Planning Board Tour: Purple Line/Capital Crescent Trail (replacing the Georgetown Branch Trail)

Completed: 11/09/11

We recommend transmitting the following comments to the Montgomery County Council:

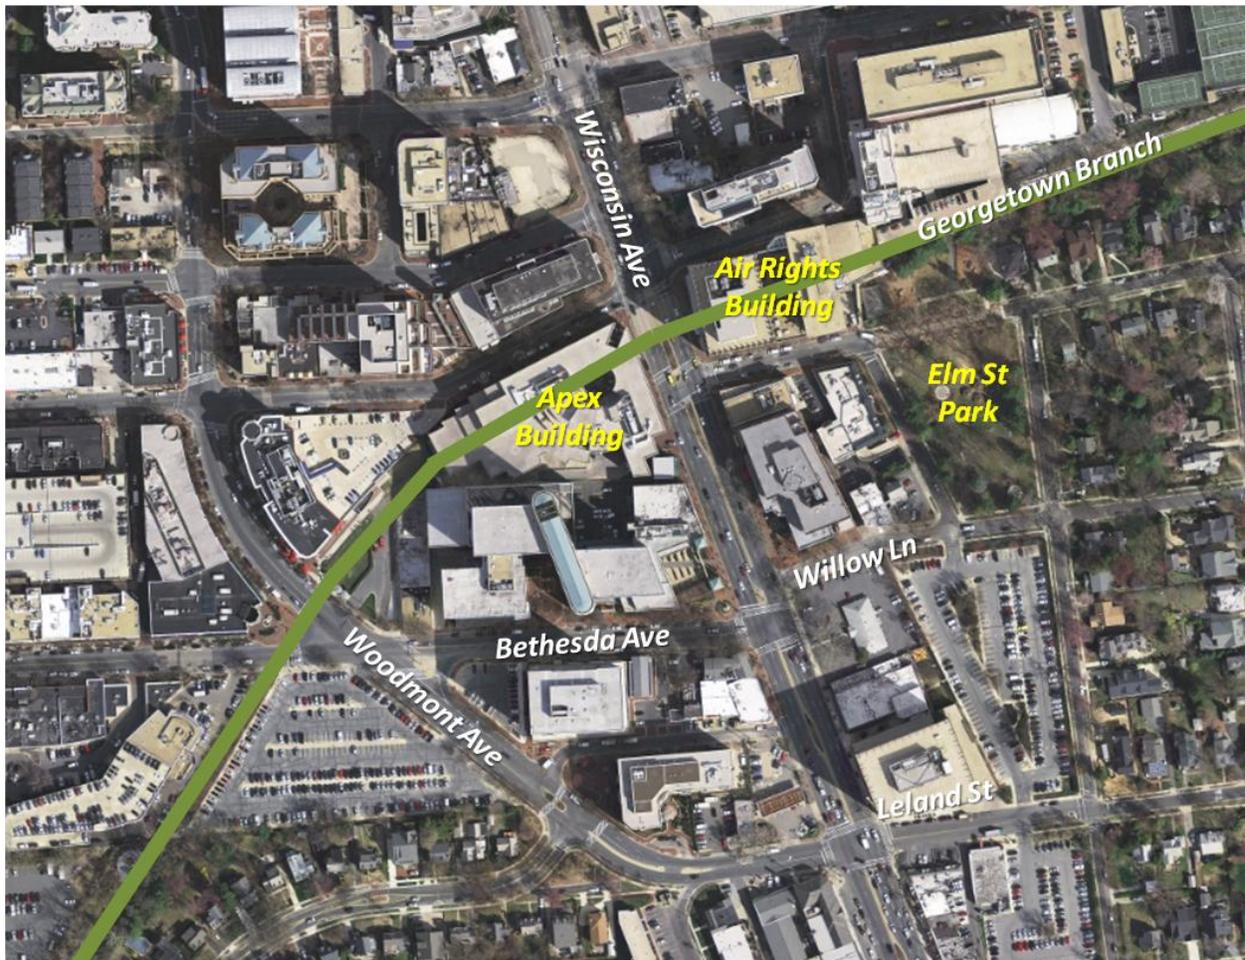
A concern of residents whose homes back up to the trail is that lighting will spill over into their homes. According to MTA's consultants, recommending closer pole spacing does not have to increase the amount of light that spills over if the lighting is designed appropriately. In fact, this spill over can be

eliminated by installing fixtures that prevent the light from rising above the level of the fixture and from extending beyond the desired area.

We recommend providing continuous lighting on the Capital Crescent Trail between Bethesda and Silver Spring to the Illuminating Engineering Society of North America (IESNA) standard for vertical illuminance and provide maximum protection for undesirable spillover. This standard of lighting is somewhat higher than the MCDOT practice for trails but is warranted because safe and secure local access is needed to the Red Line and the Purple Line and to function as a commuter trail during hours of darkness.

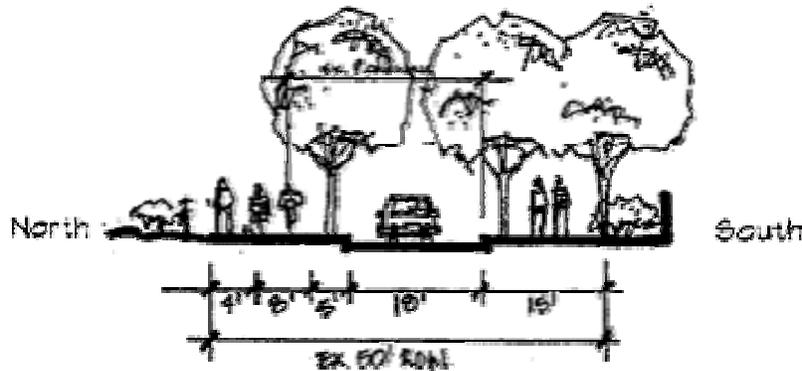
Elm Street Park: The surface alignment exits the Georgetown Branch right-of-way roughly in the middle of the park. A 10 ft trail is included in the planned redesign of Elm Street Park. However, if the trail in the tunnel is not constructed, more users can be expected on the surface alignment than is currently being planned for. **We recommend evaluating the design of the surface alignment through Elm Street Park to ensure that the trail is designed to safely accommodate the anticipated use, and to minimize negative impacts to park users and facilities.**

*Willow Avenue just east of Wisconsin Ave
Source: Bethesda CBD Sector Plan (1994)*

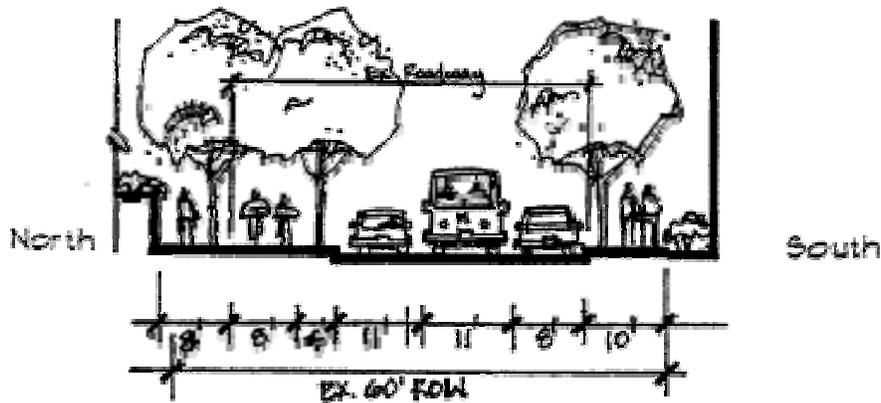
Willow Lane: The Bethesda CBD Sector Plan recommends an 8 ft surface alignment on the north side of Willow Lane adjacent to a 4 ft sidewalk and a 5 ft tree panel (see figure below). DOT is recommending a trail on the north side of Willow Lane because there would be fewer impacts to the Farm Women’s Cooperative, utilities would not have to be relocated, and to accommodate trucks turning left onto northbound 47th Street. This would require the elimination of the row of parking on the south side of Willow Lane.

We recommend that an off-road trail be located on Willow Lane and that the working group determine which side of the road to locate the trail.

Comparison of the Master-Planned Surface Alignment with Other Surface Alignments

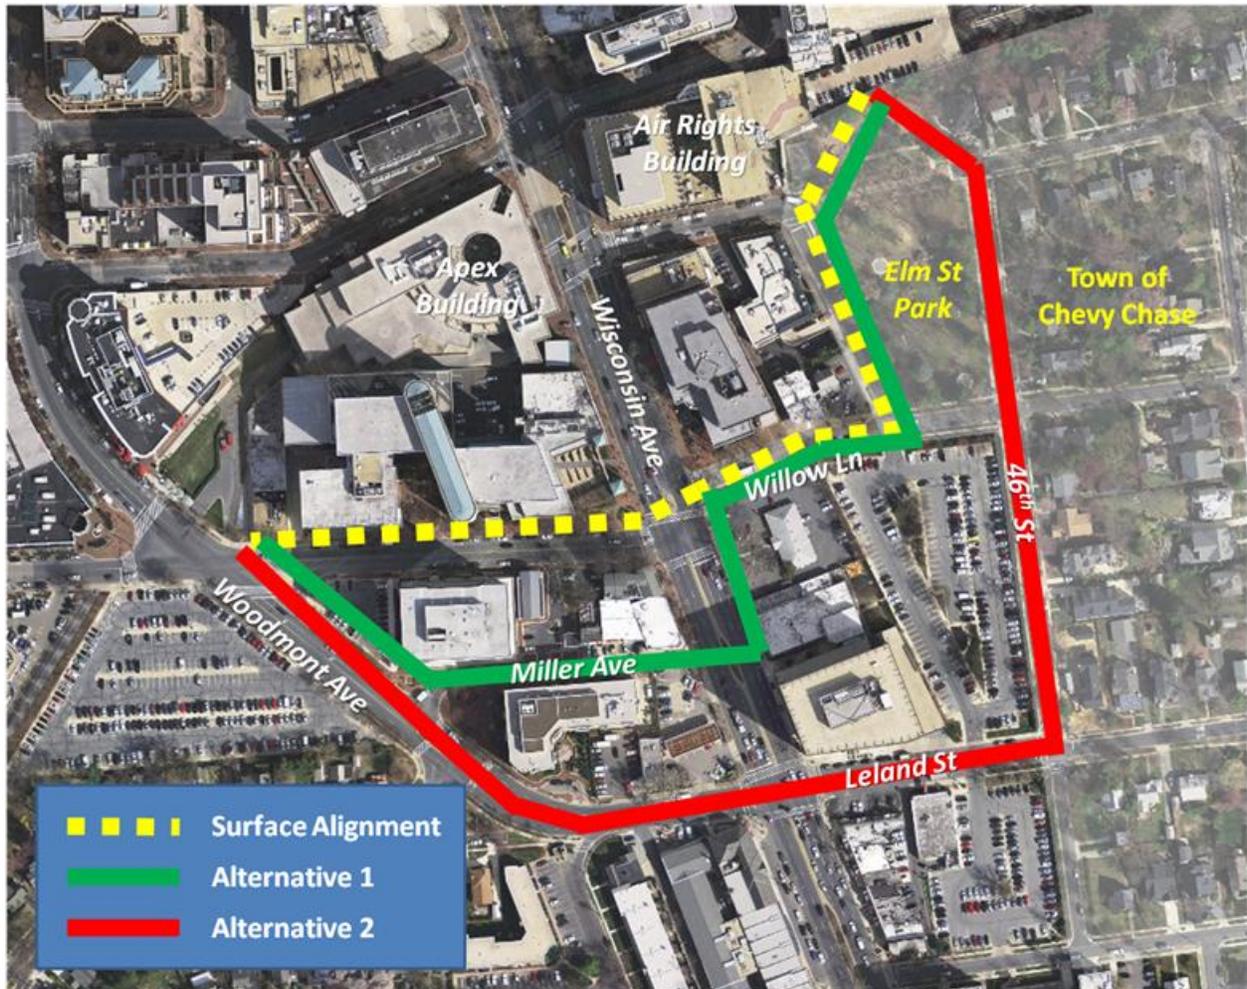
There have been several proposals to move the master-planned surface alignment from the north side of Bethesda Ave to another location. The following is an evaluation of three alternatives to the master-planned surface alignment via Bethesda Ave. They are illustrated in the figure below and compared in the table below. The master-planned surface alignment and the modified surface alignment travel along the same roads, but vary on the side of the road along Bethesda Ave.

- It has been in the Sector Plan since 1994.
- Compared with other alternatives the master planned connection has:
 - A shorter travel distance.
 - Fewer crossings at intersections.

- Fewer conflicting driveways.
- Without a plan amendment the Planning Board could not require developers to accommodate the trail if additional right-of-way is required.

We recommend that the master-planned surface route remain on the north side of Bethesda Avenue and any private development or public projects potentially affecting that route will be required or advised, respectively, that the Bethesda Avenue bike route needs to be accommodated until the following criteria are met:

- **A better surface alignment is identified.**
- **There is assurance from other parties involved – including SHA and MCDOT – that they concur with the new surface alignment and will ensure that a high-quality, safe route is feasible. Part of that feasibility determination would be based on what the impact will be on the properties along that new route.**
- **The master plan is amended.**

Figure 1 – Depiction of Average Horizontal Illuminance Only (70 foot light pole spacing)

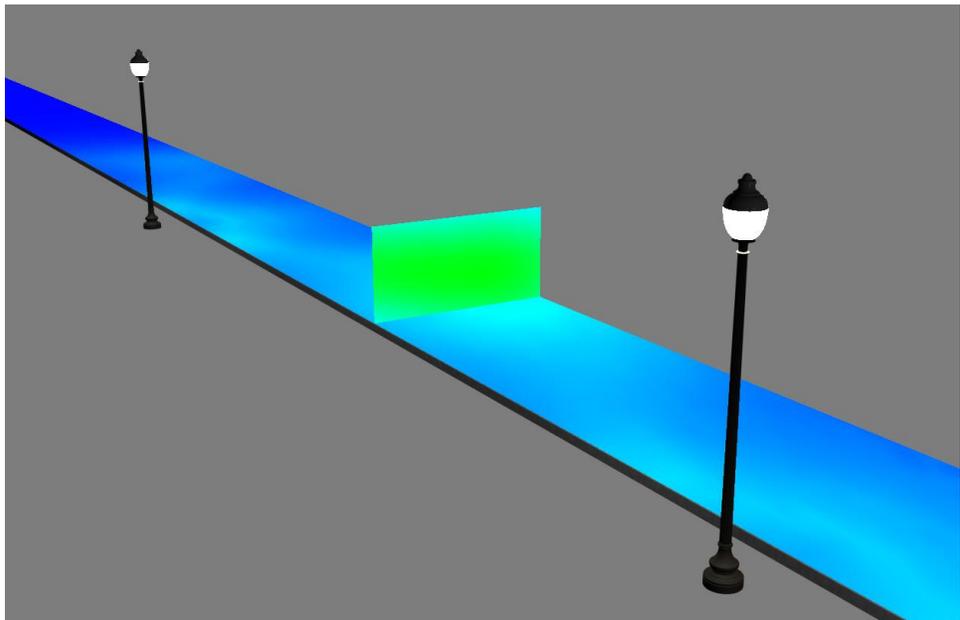
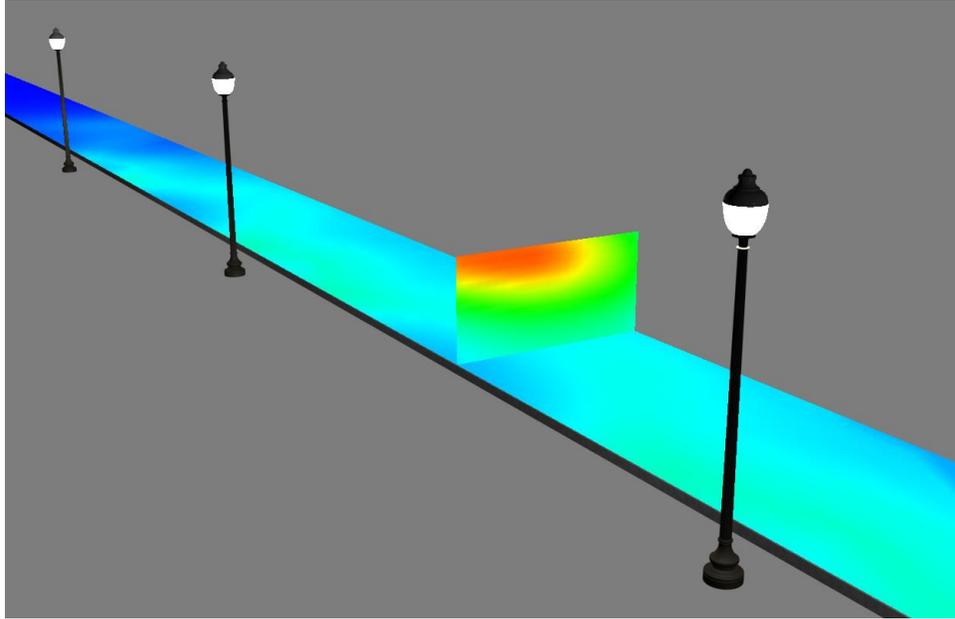
Rendering 1 below illustrates the amount of light reaching a person when only horizontal illuminance levels are considered using a light pole spacing of 70 feet. Rendering 2 illustrates the amount of light reaching a person when horizontal and vertical illuminance levels are considered using a light pole spacing of 50 feet, which results in higher average horizontal illuminance compared to Rendering 1. A graphical interpretation of the differences is shown in Figures 1 and 2 below. In these figures, cooler colors (blue to green - Figure 1) represent a lower light intensity shown on the vertical plane, warmer colors (yellow to red – Figure 2) represent higher light intensity.

- For 70 watt high pressure sodium vapor lamps approximately 450 light poles (all luminaire styles) would be required to provide a horizontal illuminance of 1.0 foot-candles on all portions of the trail in accordance with current Montgomery County practice. This would add approximately \$3.1 million (2011 dollars) to the total cost of the trail including engineering services and unallocated contingencies.
- If the vertical illuminance criteria recommended by RP-8-00 is considered, approximately 600 light poles would be required along the trail, dependent on the luminaire style chosen for use. This would add approximately \$4.2 million (2011 dollars) to the total cost of the trail lighting noted above including engineering services and unallocated contingencies.

Why Freyman Dr./Grubb Rd. and Susanna La. connectors should be consider as a pair
Circuitous routes required for trail users making connections using existing streets

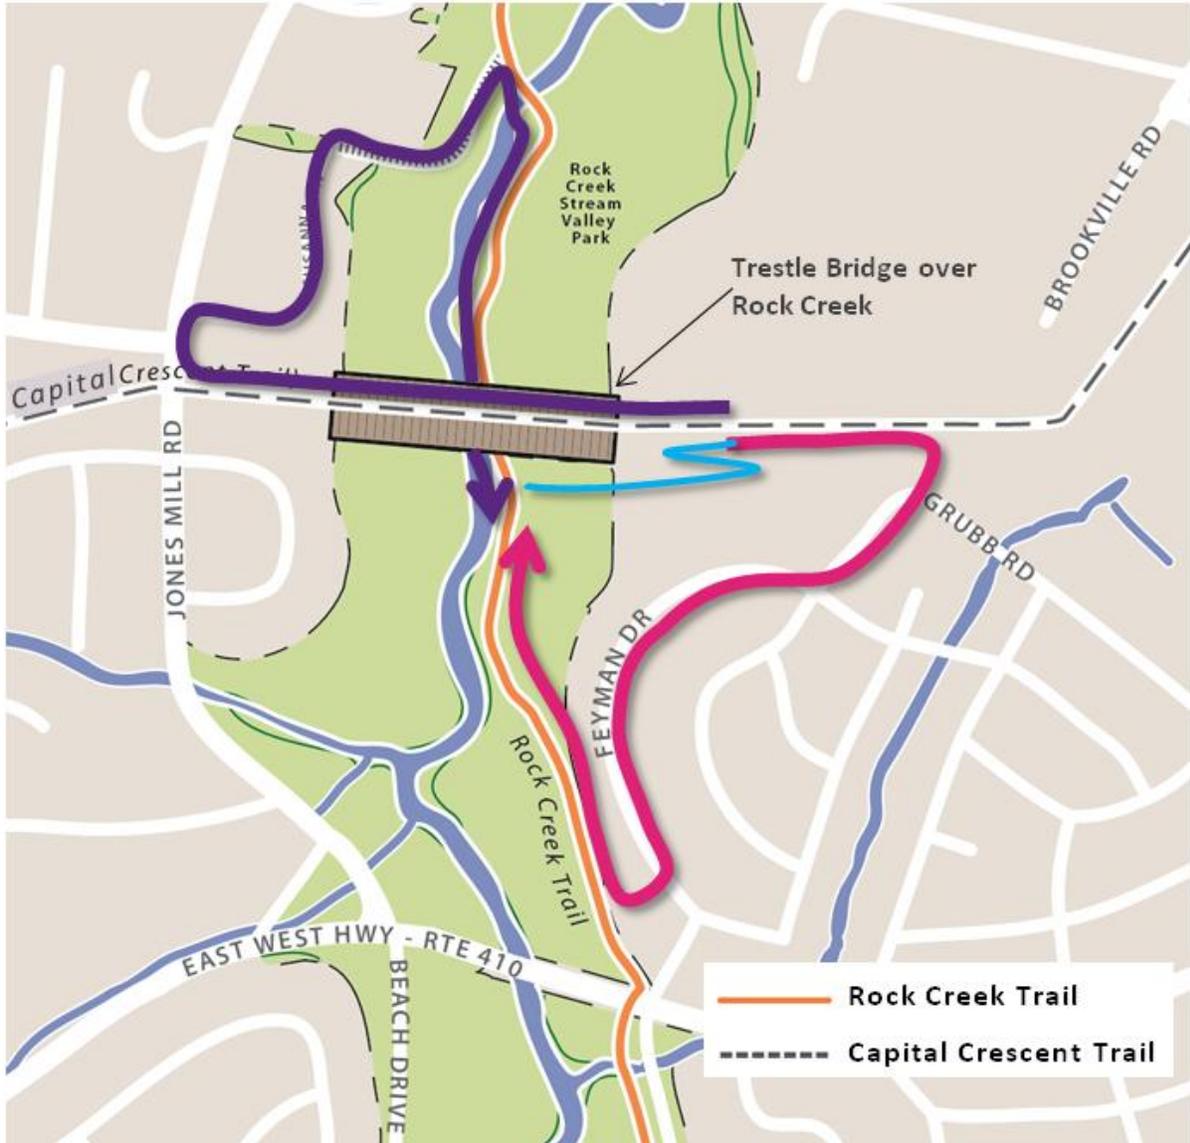
-  Susanna Lane Access to Head South (5,200' approx.)
-  Grubb Road Access to Head North (4,000' approx.)
-  Conceptual Switchback Alignment (800' approx.)
